Addendum / Addenda

Project Description / Description de projet U-66A Sound Barrier Wall		
Solicitation No./N° de sollicitation 15-22095	Project No./N° de projet 5105	W.O. No./N° d'ordre de travail A1-007095-01-02
Departmental Representative / représentant ministériel Janik Leroux		Date October 7, 2015
<p>Notice: This addendum shall form part of the tender documents and all conditions shall apply and be read in conjunction with the original plans and specifications.</p>		<p>Nota: Cet addenda fait partie intégrale des dossiers d'appel; toutes les conditions énoncées doivent être lues et appliquées en conjonction avec les plans et les devis originaux.</p>

5105-SK01

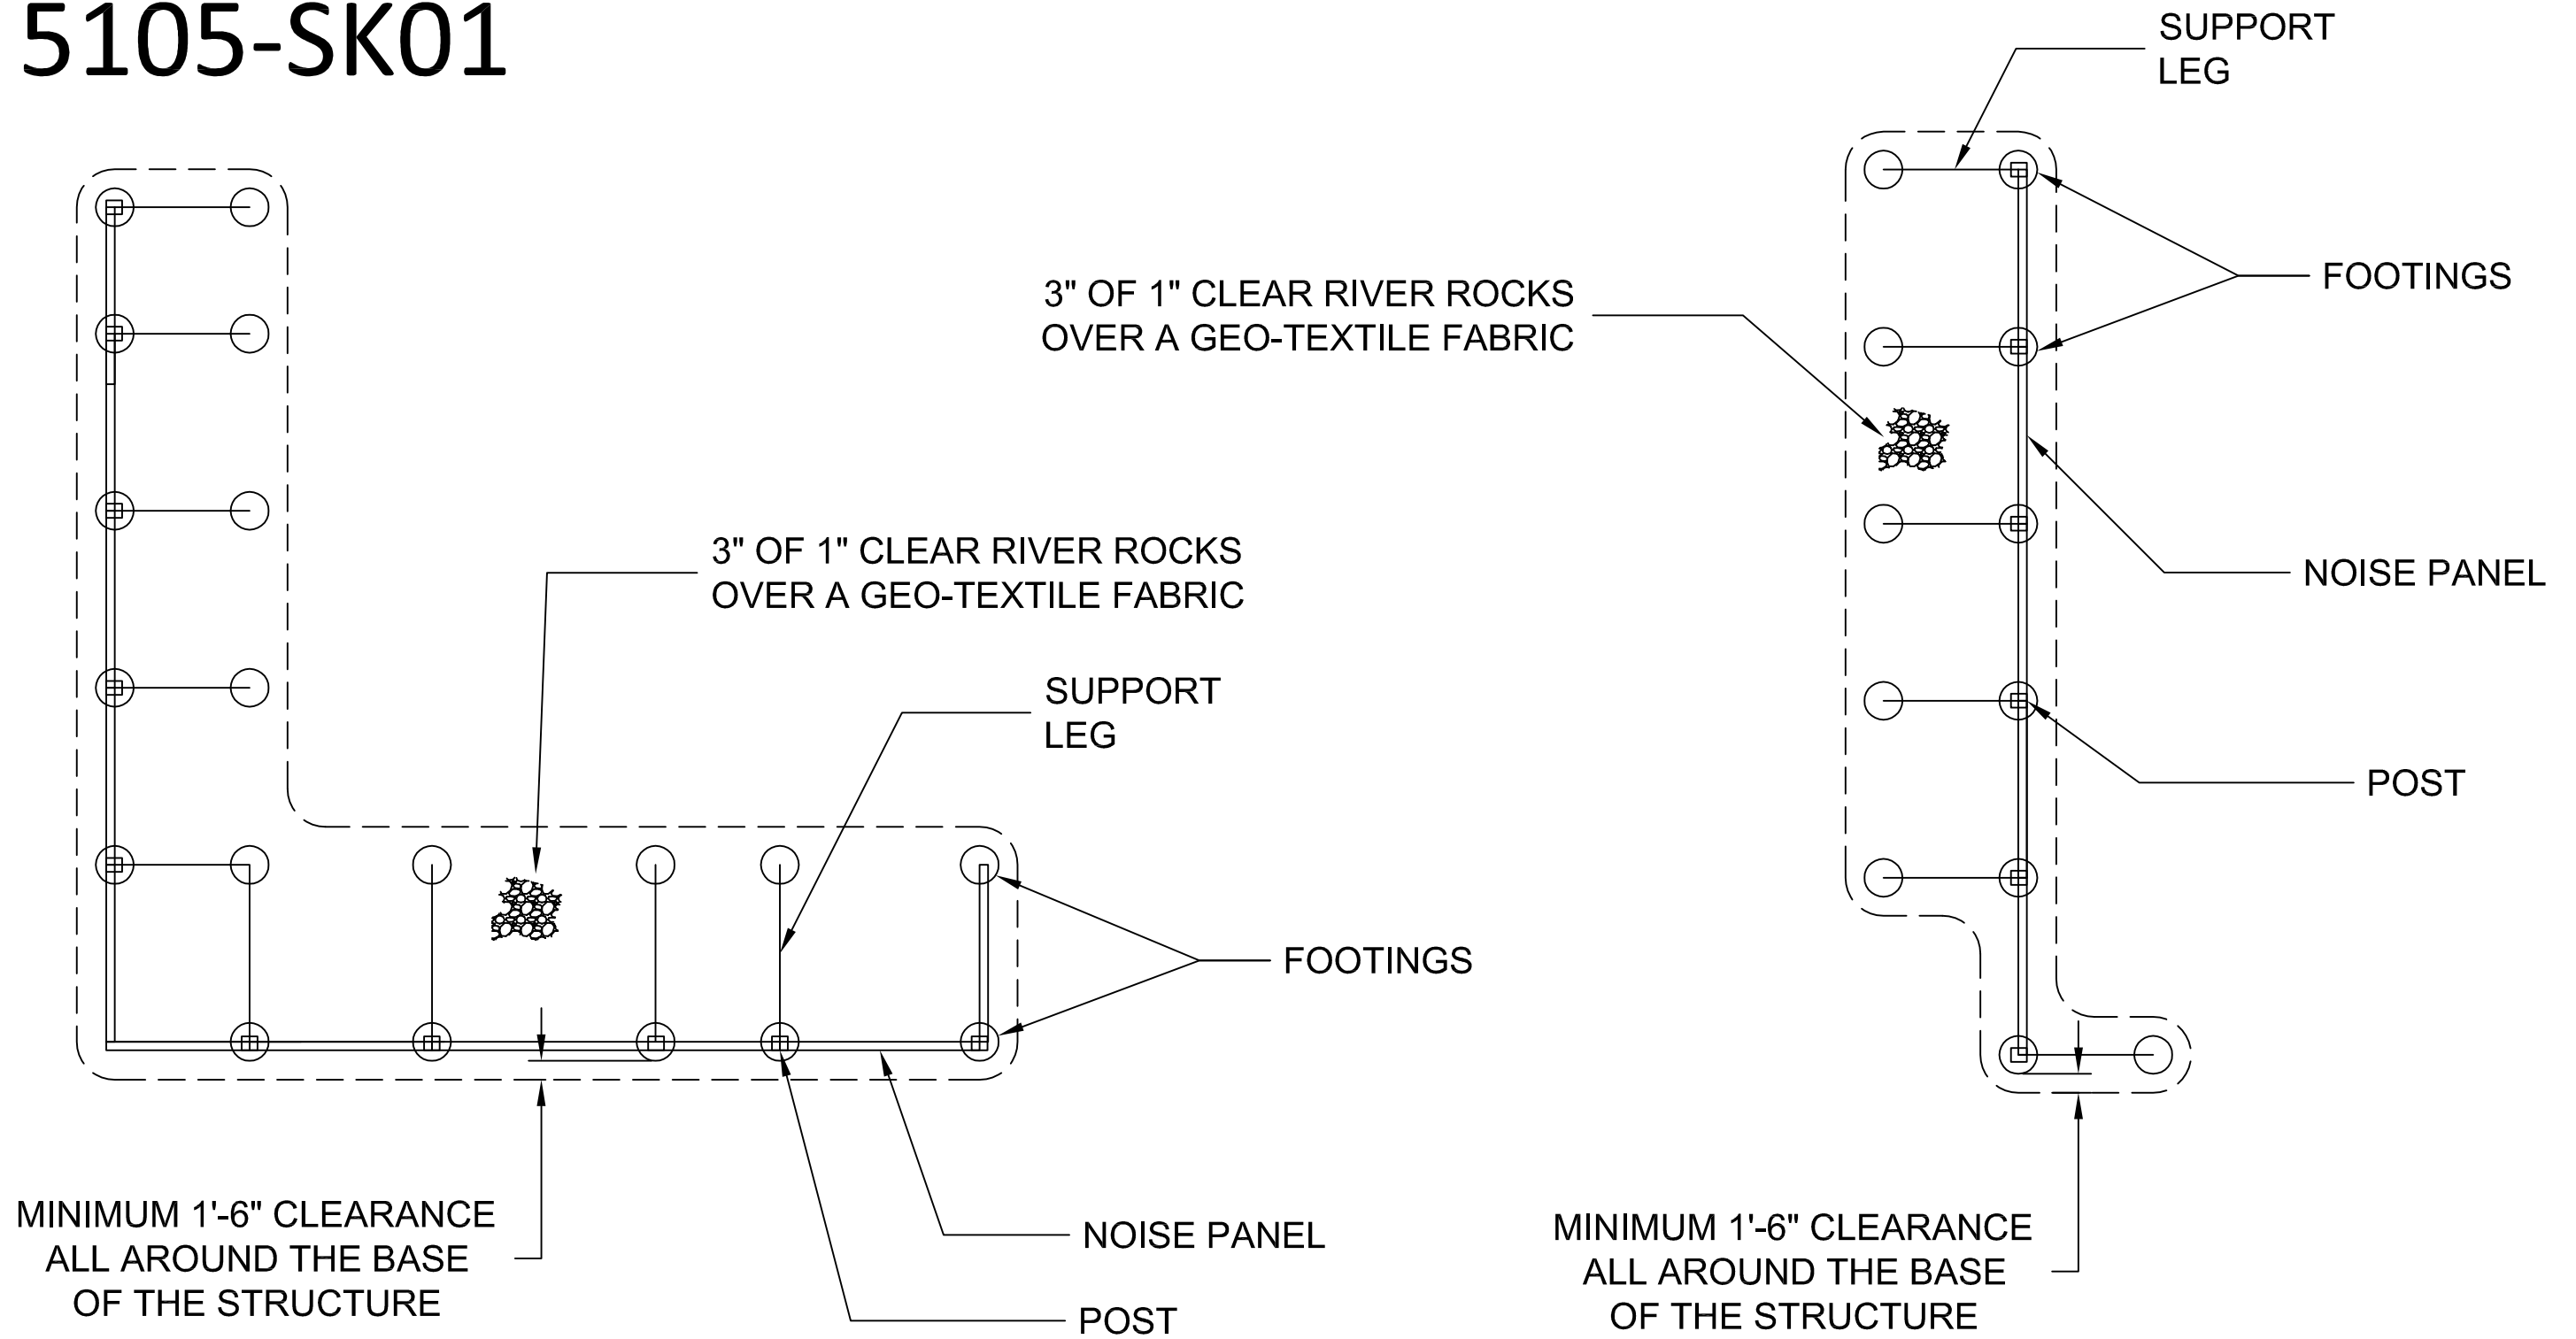
- 5) The existing chain link fence following the outline of the new Noise Barrier Wall at the tunnel's inlet is to be completely removed and modified to end at approximately 4" from both extremities of the new wall.**

7) On page 40 of Appendix "I", Replace section **11.1.3 Landscaping** with:

Provide 3 inches of 1" diameter river rock over geotextile fabric around the perimeter of the new walls as per attached drawing 5105-SK01.

Remove a section of chain link fence, turn over to NRC Departmental Representative the excess fencing. Tie in the fence at the new sound barrier walls.

The grounds around the site are grassy / sandy areas with generally very good drainage. The contractor shall be responsible to repair any ruts, or holes left in the grounds by their vehicles, rented machinery or equipment.
